## PLANNING & ZONING COMMISSION AGENDA

**Subject: Development Clearing Permit – Brighthouse Learning 21464 Clear Creek Drive**

**Subject: Variance 101 Abita Oaks Blvd**

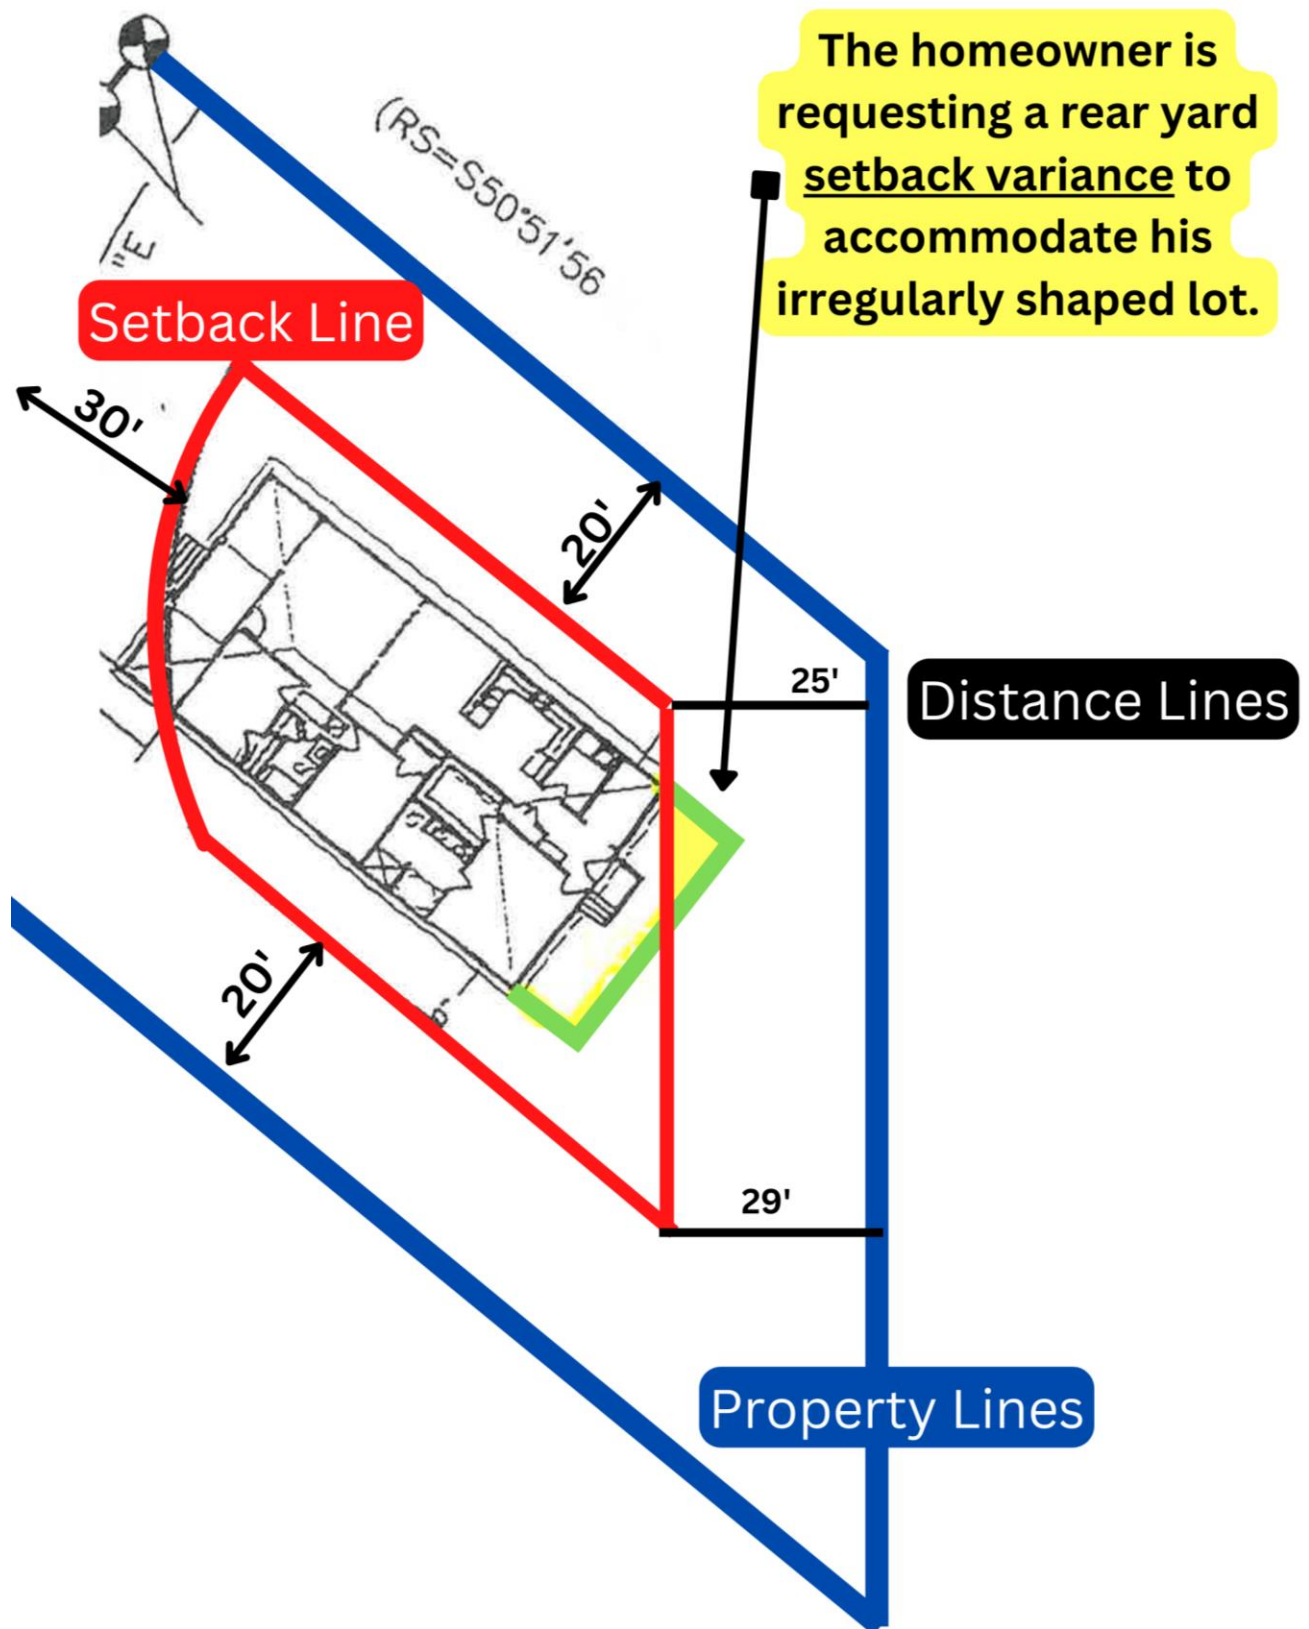
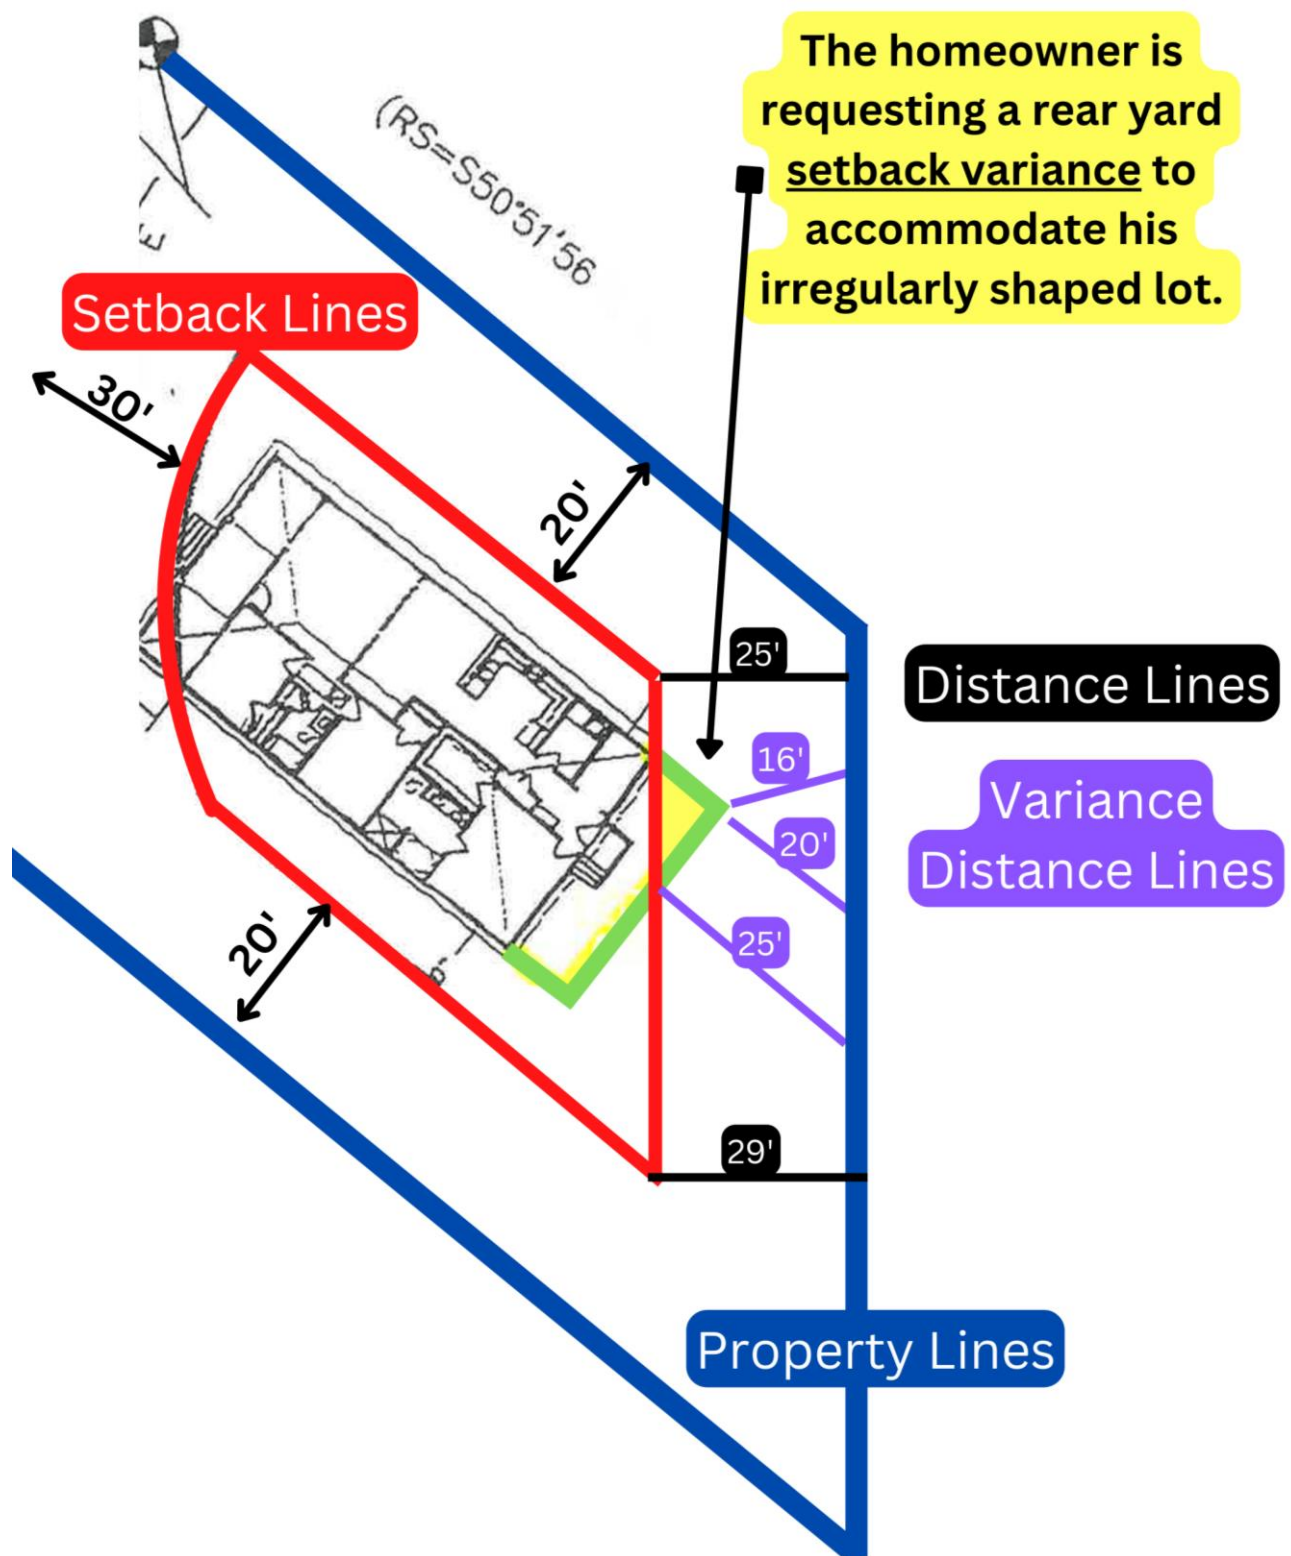
The subject property is zoned Residential District and is within the Residential-Commercial Overlay District. The property is approximately 11,815 square feet in size and has recently been developed with a single-family residence. The variance request is to construct a patio cover for the rear yard that extends nine (9) feet into the required 25-foot rear yard setback.

As specified in Town Code Sec. 9-223 (a)(2). the rear yard setback must be 20 percent of the lot depth or 25 feet, whichever is greater. The depth of the subject property varies from 112 feet on the north property line to 145 feet along the south property line. Consequently, the rear yard for the property varies from 25 feet in the area where the variance is proposed to 29 feet in the southernmost portion of the property.
